ADDENDUM NUMBER TWO

RFQ #24-911-46

ARCHITECTURAL AND ENGINEERING DESIGN SERVICES FOR FISCHER I AND III - EXTERIOR AND INTERIOR REPAIRS

Revitalization of Fischer Housing Development

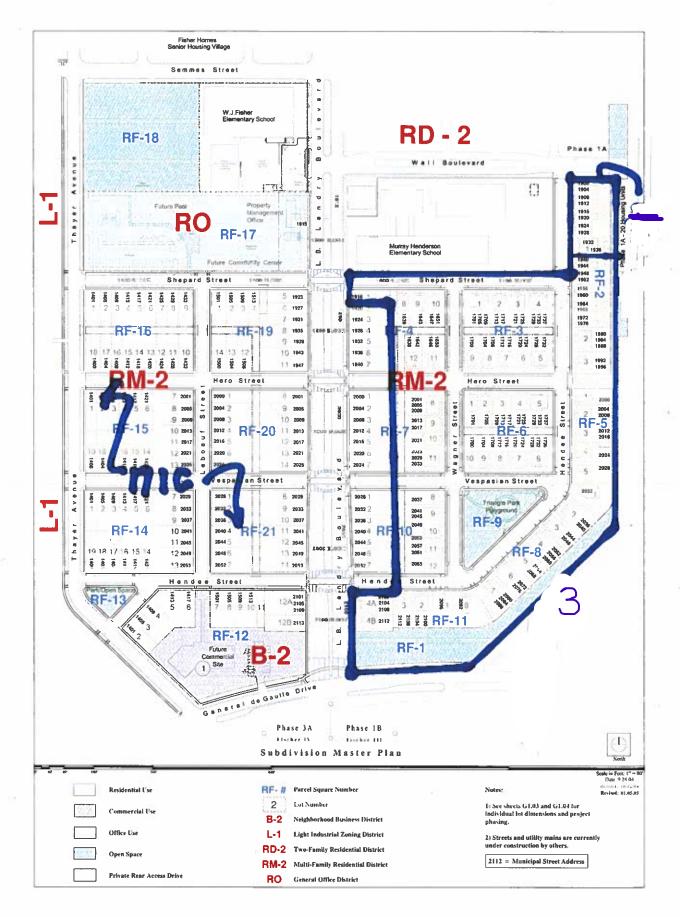
9. Is it possible to provide site plans for Fischer I and III, indicating at a minimum, the number and type of buildings located on each site?

Answer: The site plan for Fischer I and III is attached and made a part hereof.
